REMARKS

AMENDMENT TO THE DRAWINGS

FIG. 1

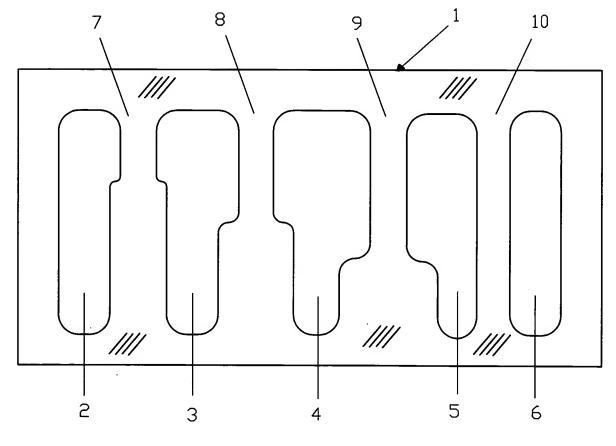
In response to the Examiner's comments in paragraphs 1 and 2, Figures 1, 2, and 4 have been corrected to show rounded corners described by ninety degree arcs joining any two adjacent sides. Pursuant to 37 CFR §1.121(d), the corrected drawings showing the proposed changes in red are hereby submitted to the Examiner for approval. Applicant has also submitted new drawings (Figures 1-6) in compliance with 37 CFR § 1.84 (c).
